Addendum No. 2
To the Plans and Specifications of

Escambia County Fire-Rescue
Paradise Beach – Station 20
1250 Bauer Road
Pensacola, Florida

Four Pages + Attachment(s)
August 4, 2026

A101
FLOOR PLAN

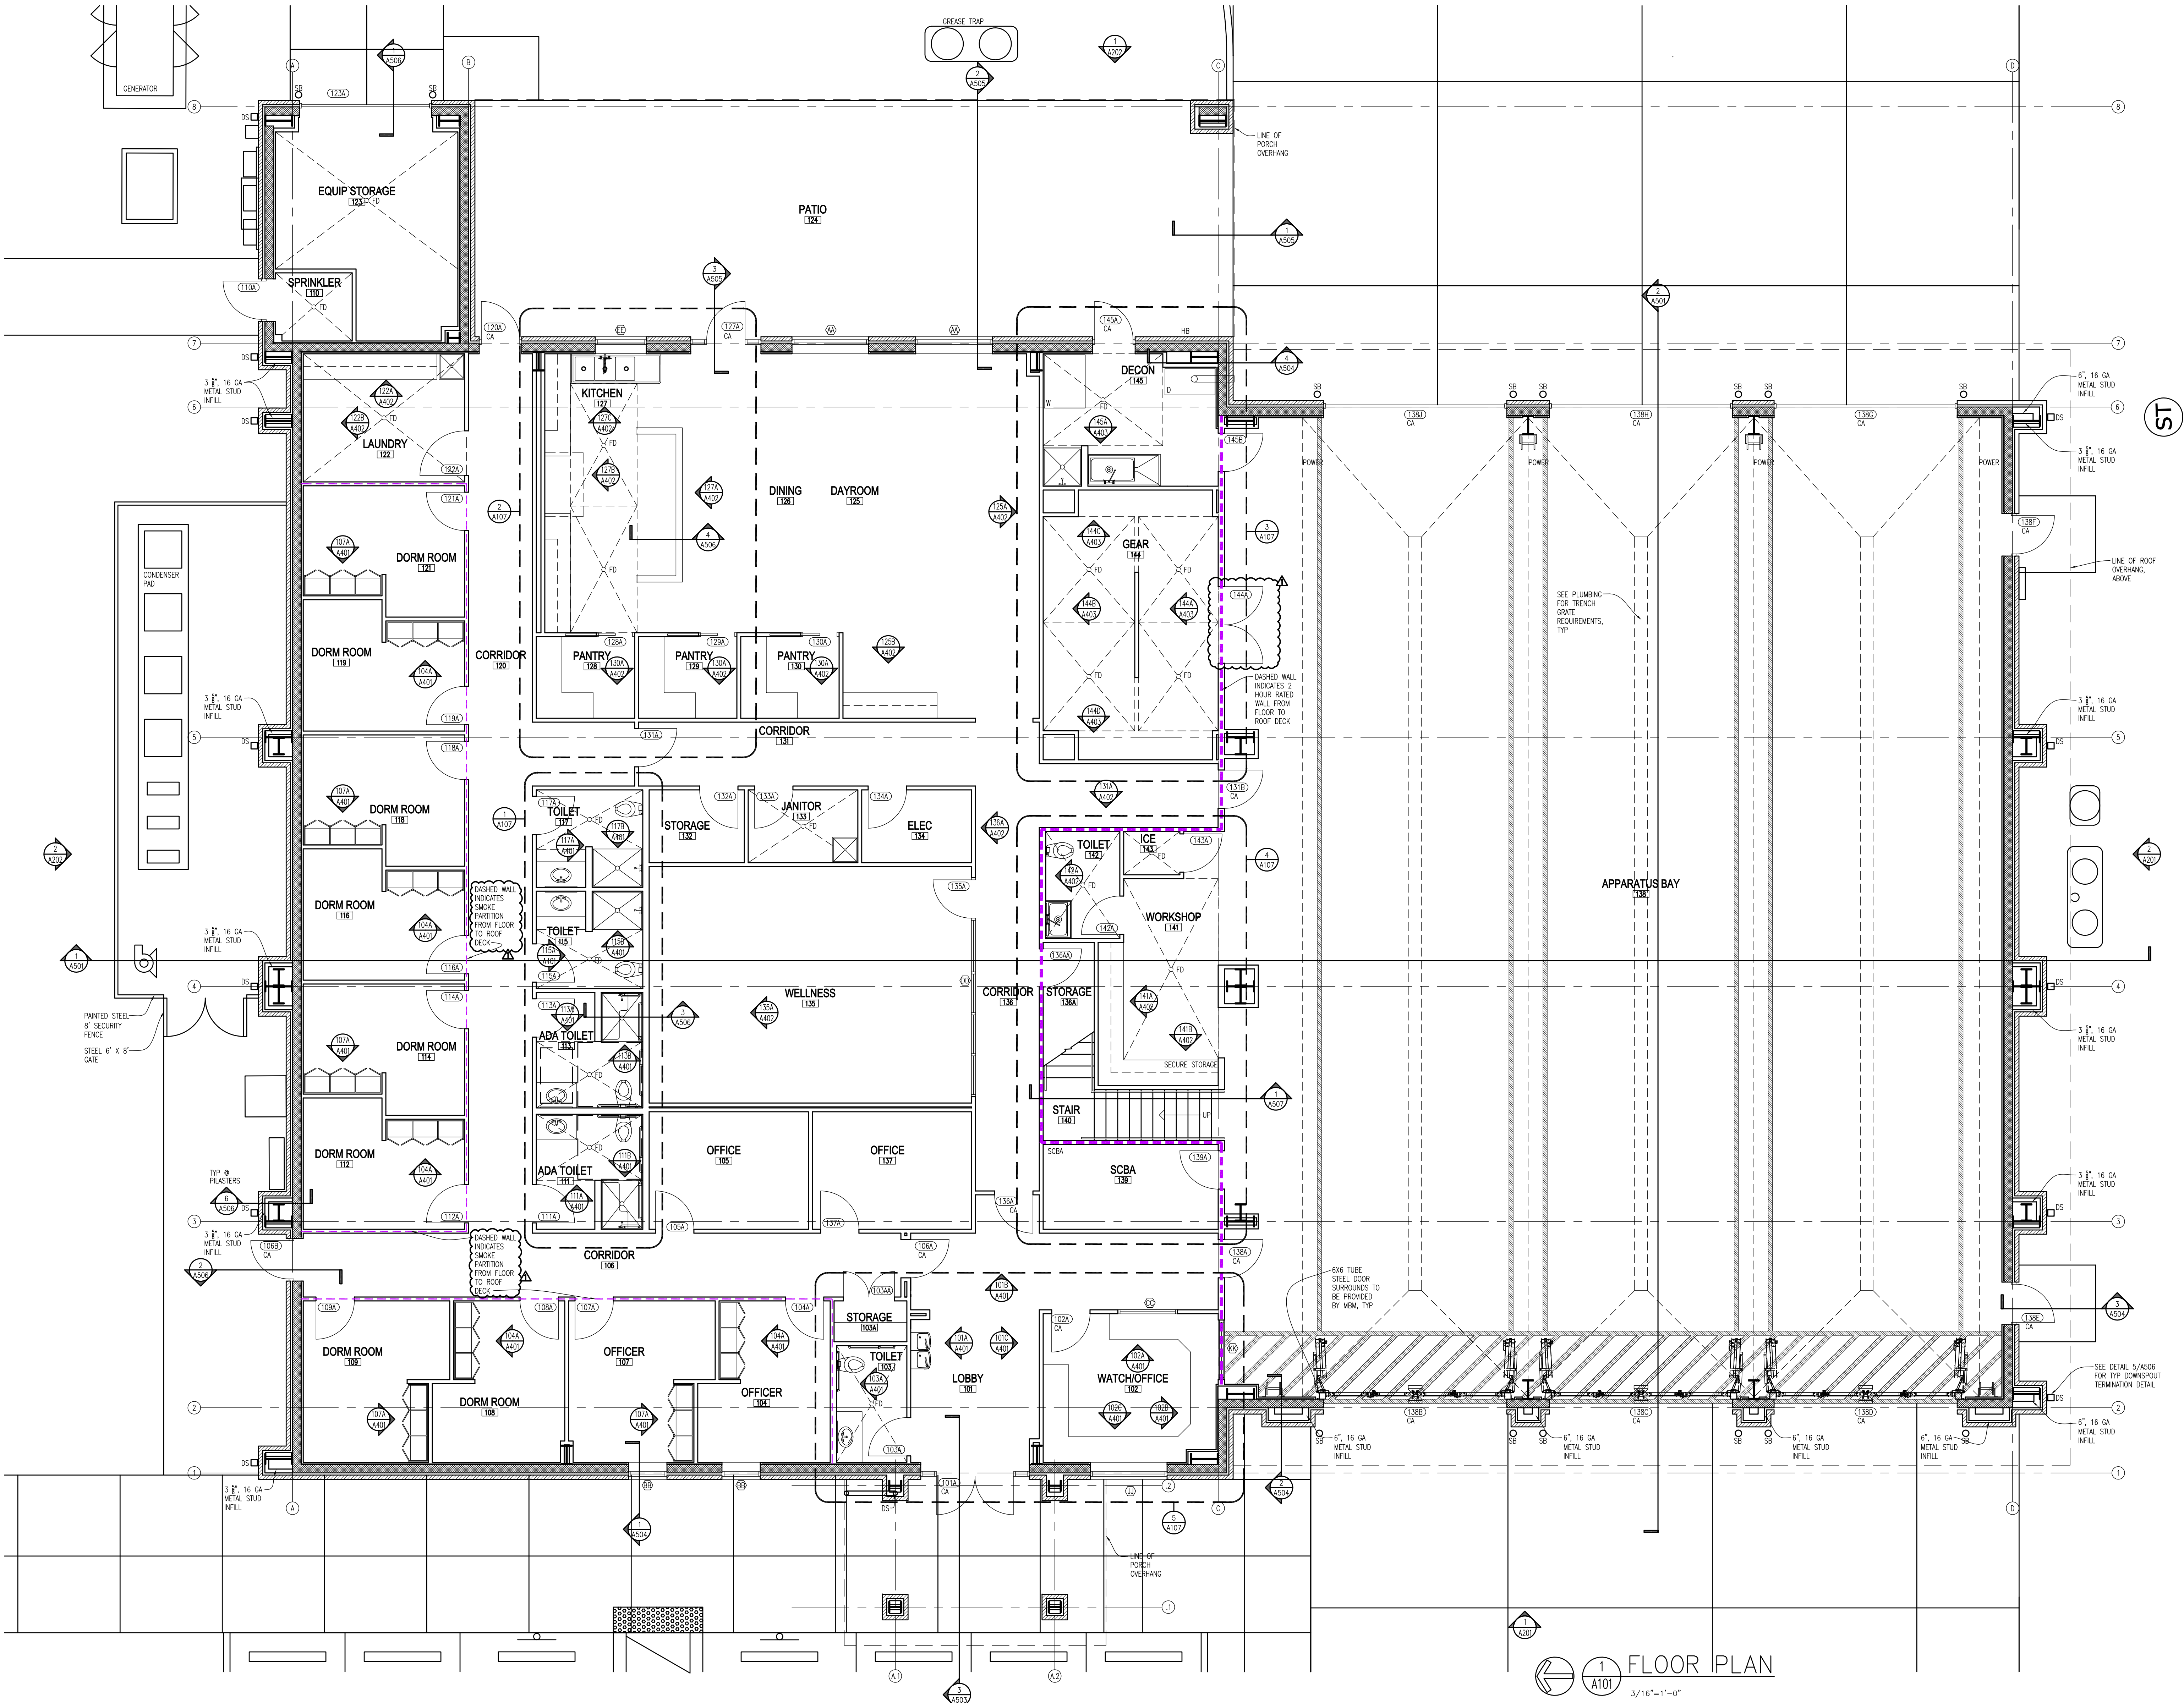
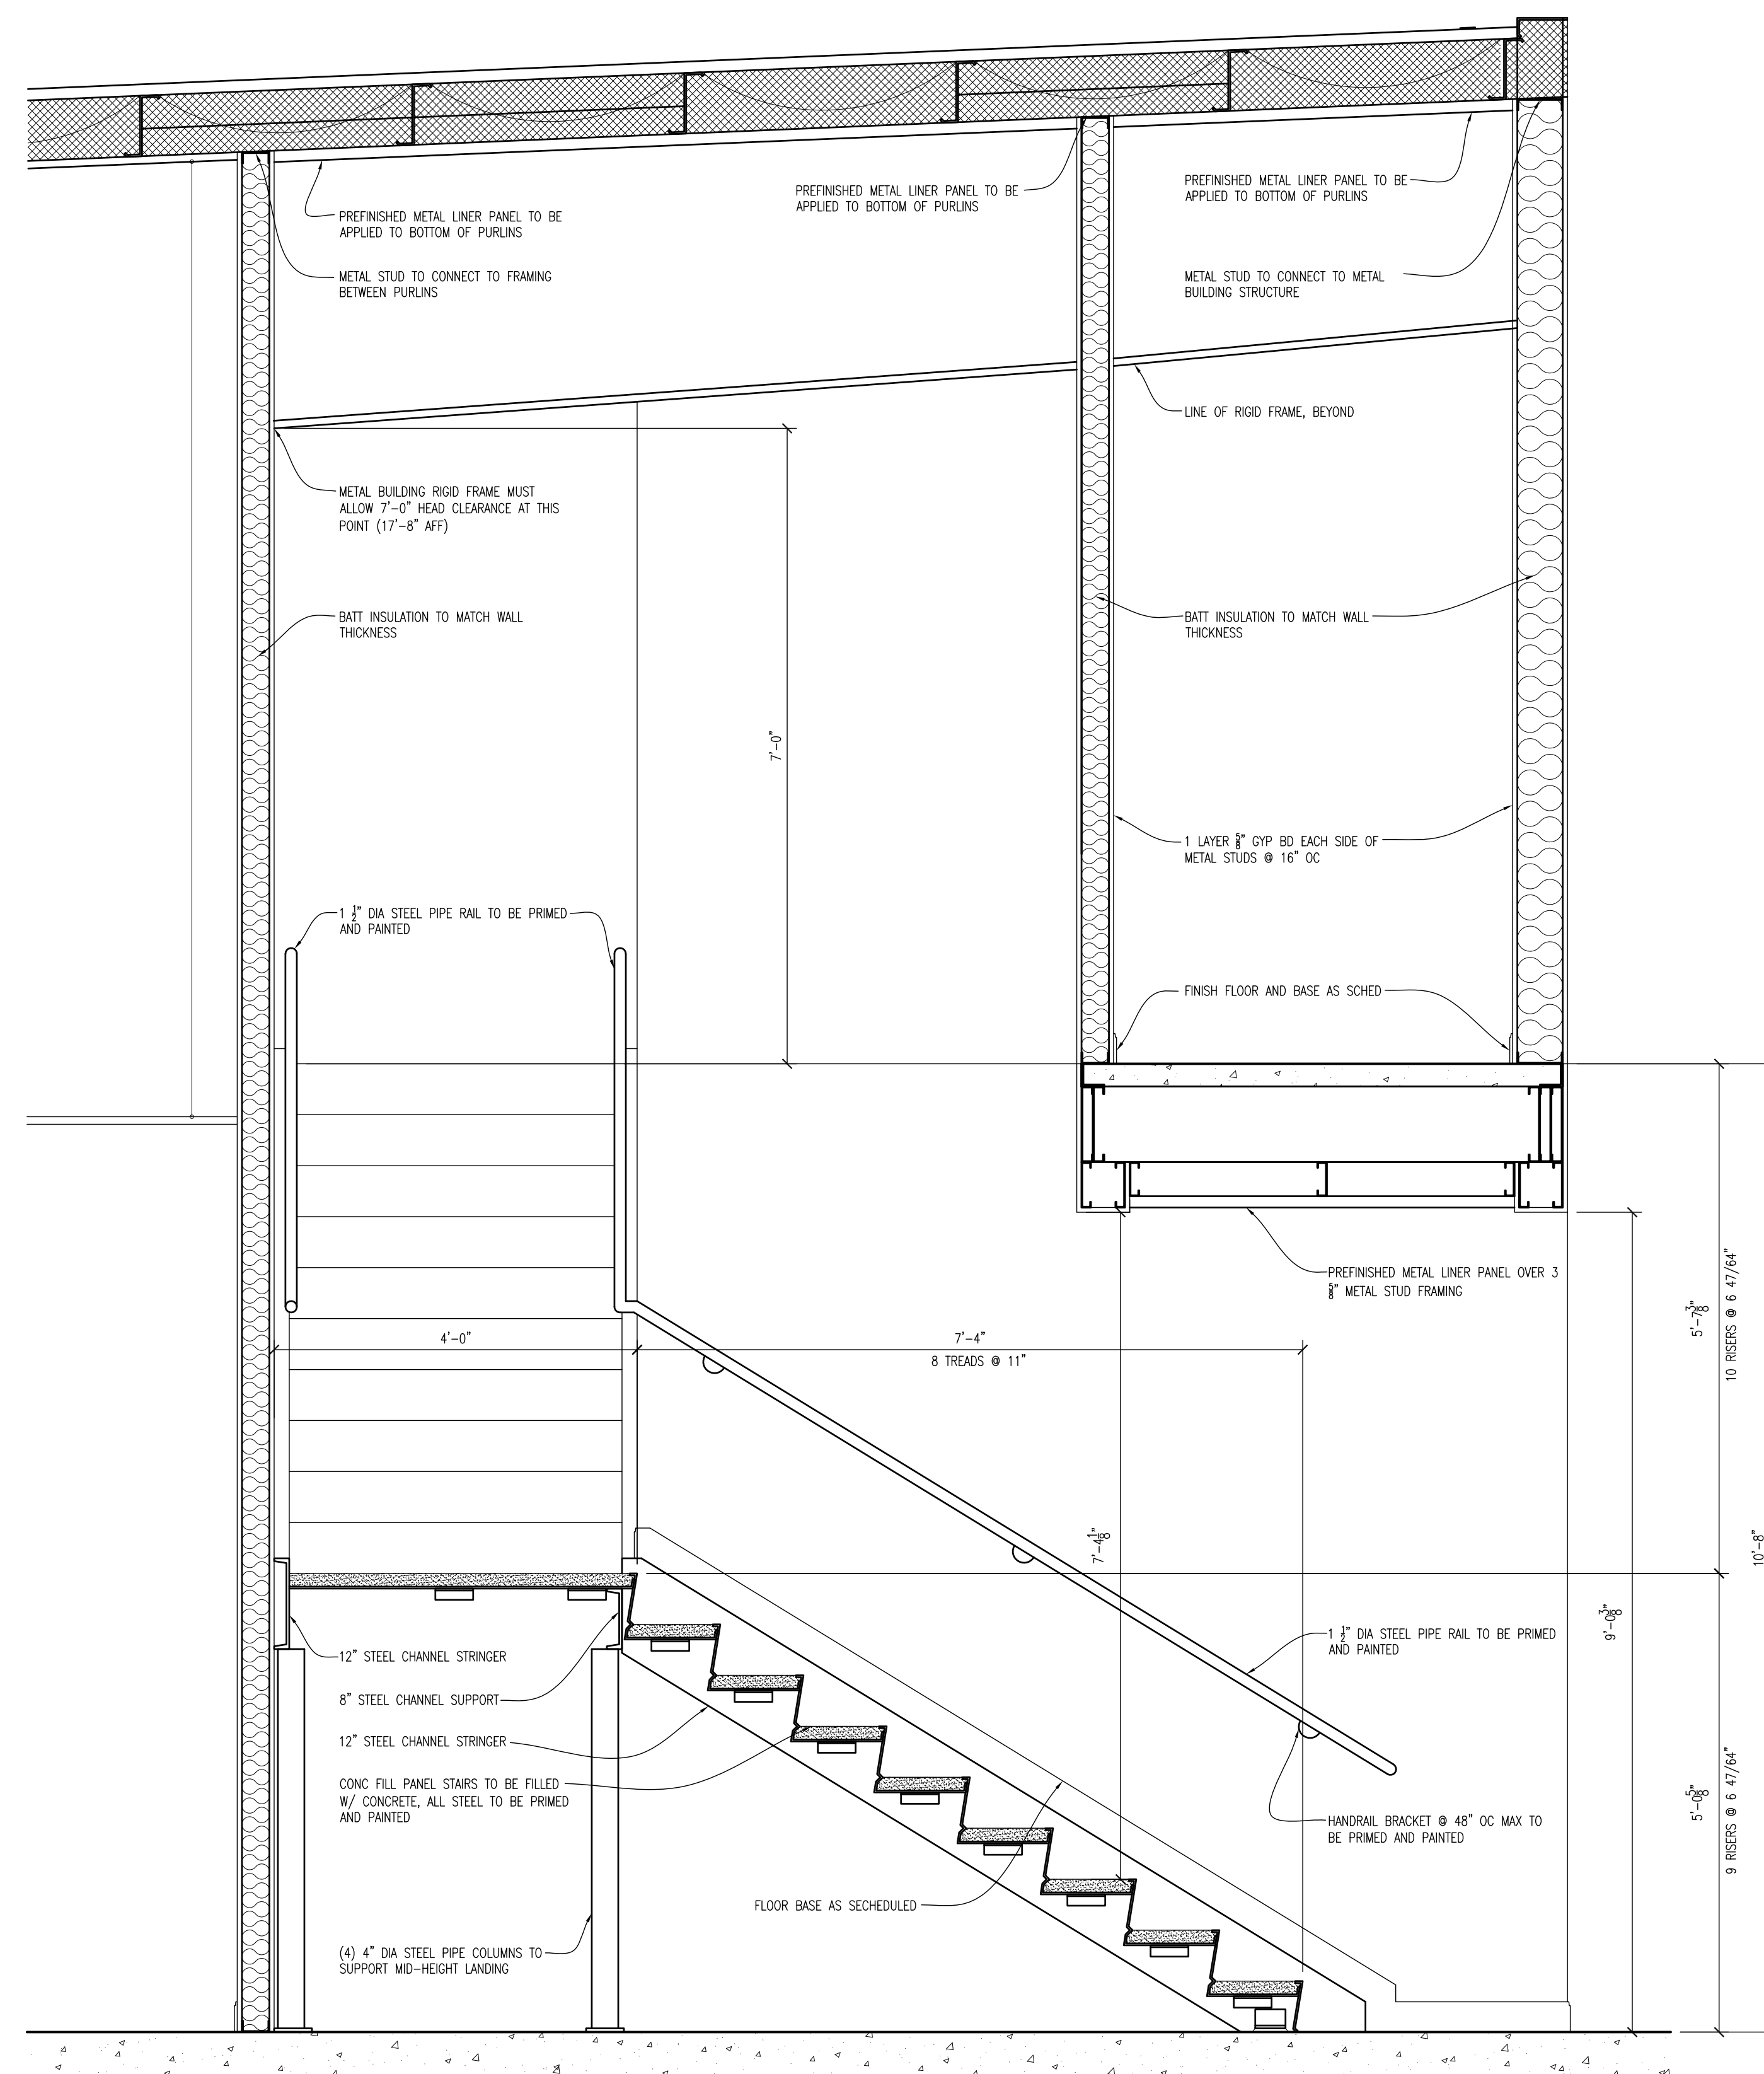
- A1. Sheet A103 – Add one addition #063 Semi-recessed fire extinguisher cabinet to apparatus bay.
- A2. Sheet A101 – The fire marshal is requiring that the walls that separate the dorm rooms from the corridor be classified as smoke partitions. See enclosed revised Sheet A101 for location of smoke partitions. Since these walls are already scheduled to be constructed from floor to roof deck, they do comply with this requirement. Walls will need to be sealed to bottom of vinyl backed insulation at roof deck. Any penetrations through these corridor walls will need to be sealed with sealant that meets requirements of a smoke partition. USG Firecode Smoke-sound sealant should be applied beneath the bottom track of stud wall.
